TECHNICAL DRAINAGE STUDY  
(RESPONSE TO CCRFCD COMMENTS)

**Skye Canyon  
Detention Basin 1**  
City of Las Vegas, Nevada

Job No.: OLY1401.004  
Date: October 2015

**Subject: Response to CCRFCD Comments on the Technical Drainage Study for  
Skye Canyon – Detention Basin 1 (CLV-DS4698, RFCN No. 15-9550)**

HOASE INTERCHANGE  
NEW SD CONNECTION

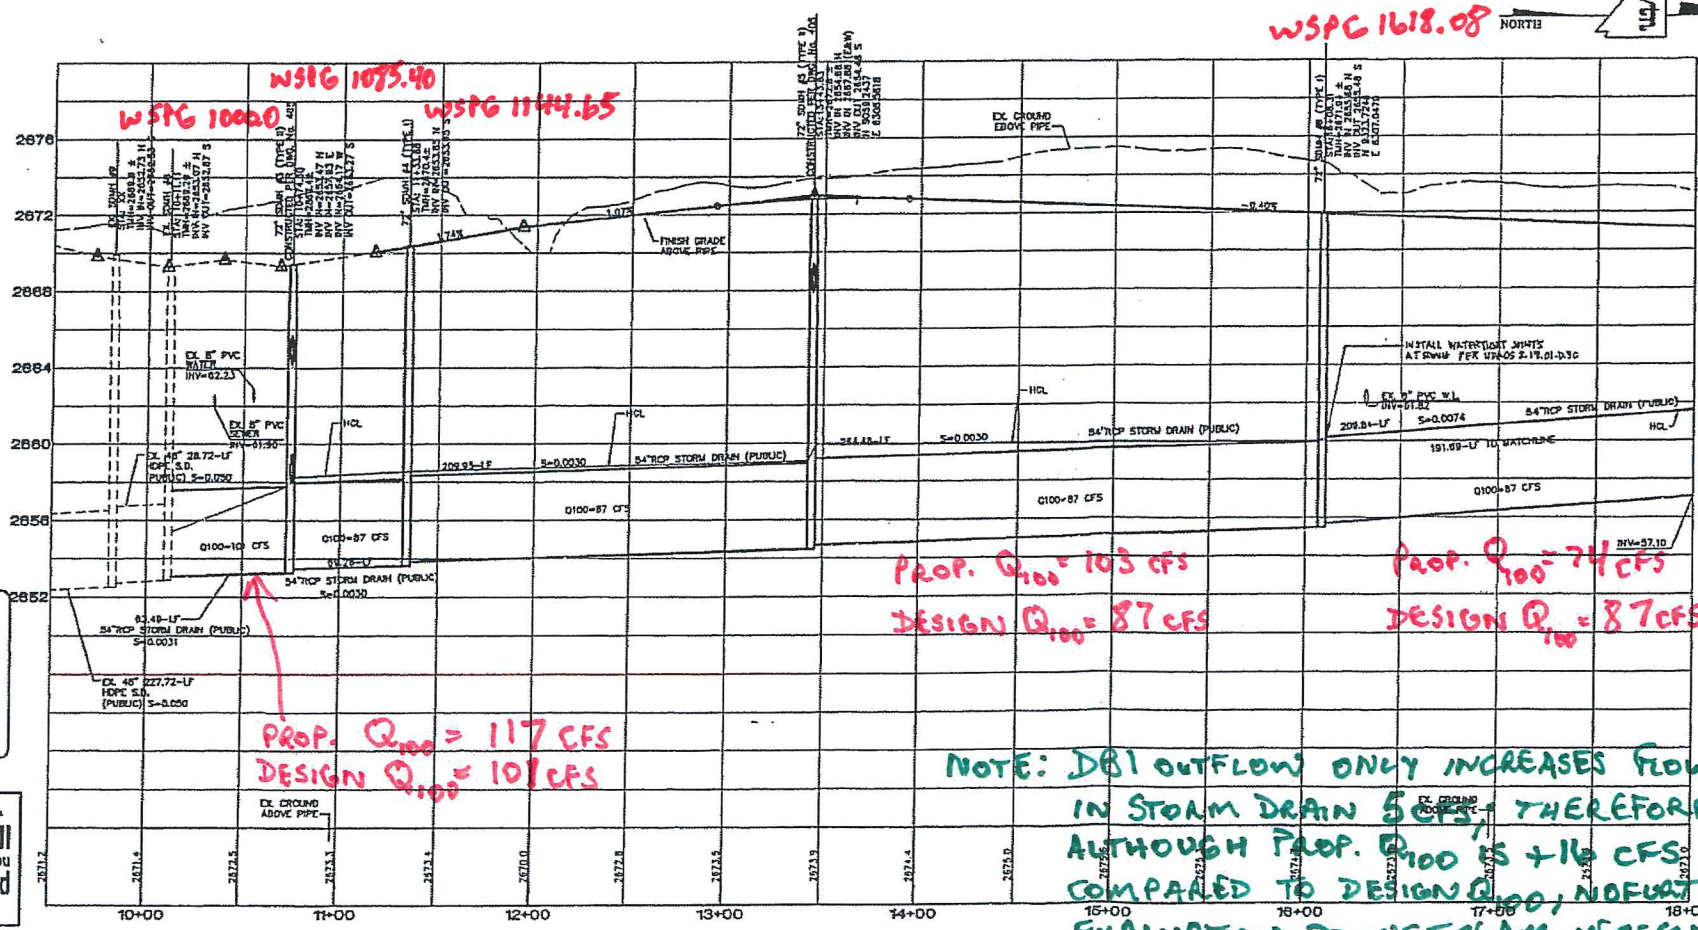
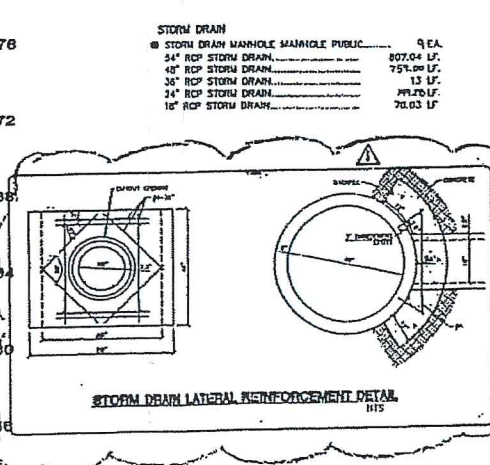
NOTE: DBI OUTFLOW ONLY INCREASES FLOW  
IN STORM DRAIN 5 CFS; THEREFORE,  
ALTHOUGH PROP.  $Q_{100}$  IS +16 CFS  
COMPARED TO DESIGN  $Q_{100}$ , NO FURTHER  
EVALUATION DOWNSTREAM NECESSARY.

# 60-inch RCP "Free-Flow" Outflow Pipe

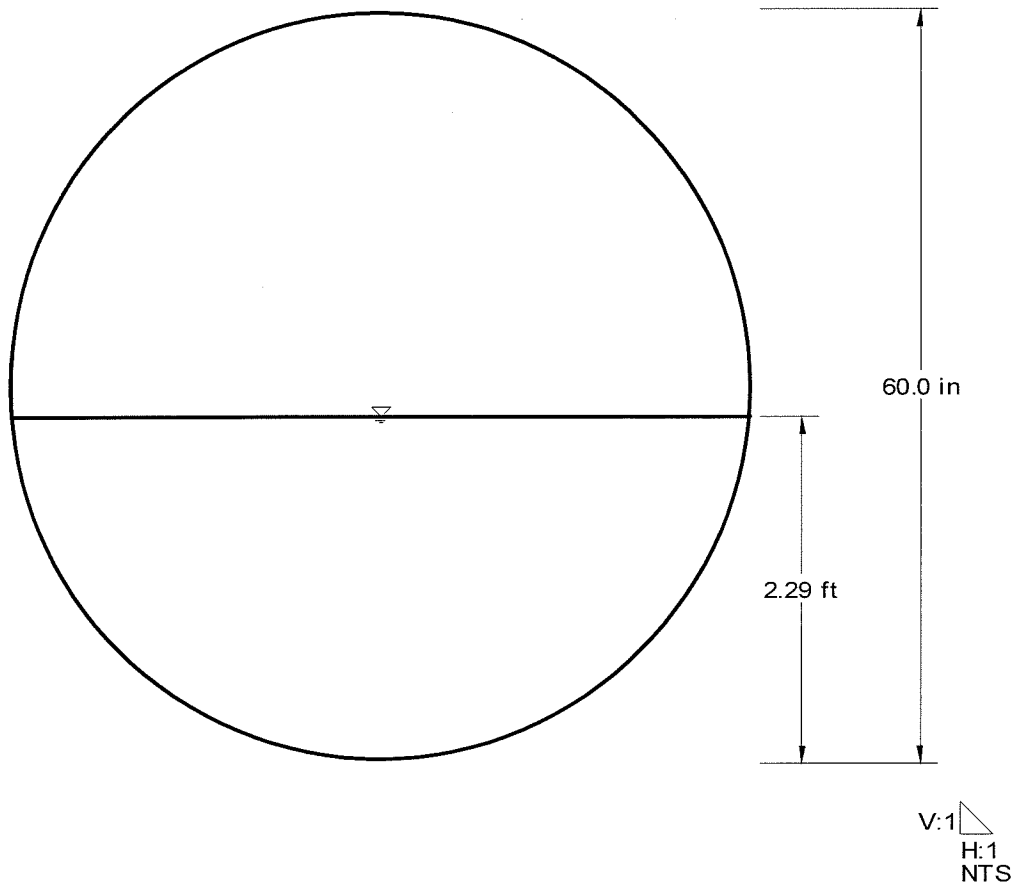
- c. HEC-1, Line 93 (SA/SE cards): Provide surface area/elevation calculation for verification.
  - d. The 24-inch orifice discharge curve calculation is annotated with consideration to a 2.5' depth in the 60" RCP. Clarify this calculation and update calculation accordingly based on the current design.

→ DOESN'T EXCEED 2.5' (1/2 FULL);  
THEREFORE, TAILWATER OF 2.5' UTILIZED  
IN 24" ORFICE CALCULATION IS  
CONSERVATIVE & OK
